# 1960 Corvette: Service Bulletin: Instrument Lens Cracking and Checking

**Bulletin No:** DR #448

**Date:** August 23, 1960

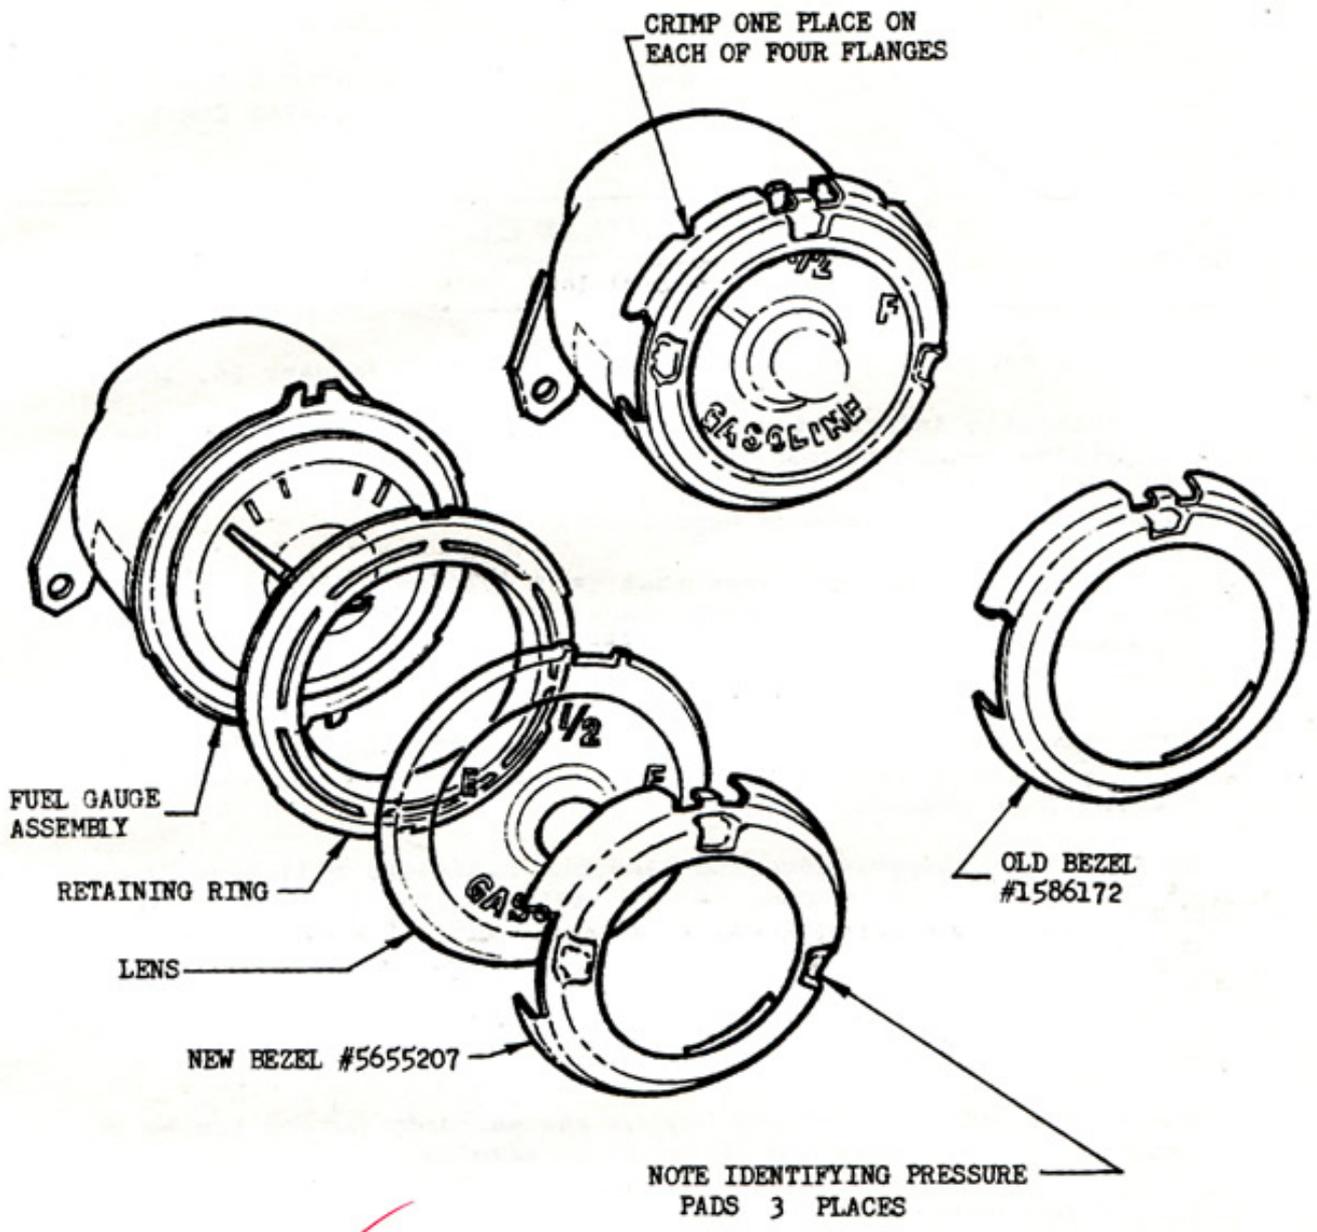
Field complaints of instrument lens cracking or checking on 1960 Passenger Cars have been traced to the means of lens retention in the various instruments.

A revised retaining bezel has been released for production and is available in Service Parts Stock. Three bezel pressure pads have been added and the number of crimps has been changed from eight to four as shown in the illustration.

When replacing a damaged lens, it will also be necessary to replace the first design bezel with the revised bezel listed below. no changes has been made to the individual fuel, temperature and tell-tale lenses.

The new bezel should be crimped in one place on each of four flanges as shown in sketch after it is positioned over the lens. When reinstalling gauge

assembly to instrument panel, tighten mounting screws a minimum amount necessary to remove looseness and rattle of the lens. Do not overtighten!
